FMM640 Product Change Notifications

Product change notifications (PCN) is the way of informing customers of upcoming changes related to Teltonika products. This includes outward appearance adjustments, hardware improvements, firmware changes, changes to package contents, etc. This page stores information regarding changes to the FMM640 tracking device. Below you will find a list of both upcoming and already implemented changes sorted from newest to oldest (top to bottom).

2021.08.16: SMA soldering changes

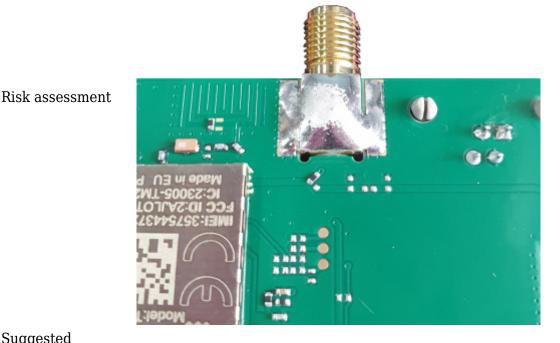
We would like to inform you that Antenna connectors (SMA SMD type) in FMM640 devices will be soldered from both sides of PCB starting in first half of September 2021.

Change reasons/Description In order to increase the structural rigidity and unify the manufacturing process of Teltonika IoT Group devices, SMA connector will be soldered on the top side of PCB (same as before) and on the bottom side of PCB (performed additionally).

Due to THT assembly process, some devices might have an excess amount of soldering on the SMA connector.

This does not affect GSM/GNSS antenna characteristics and does not interfere with device case assembly, therefore, device functionality remains unchanged.
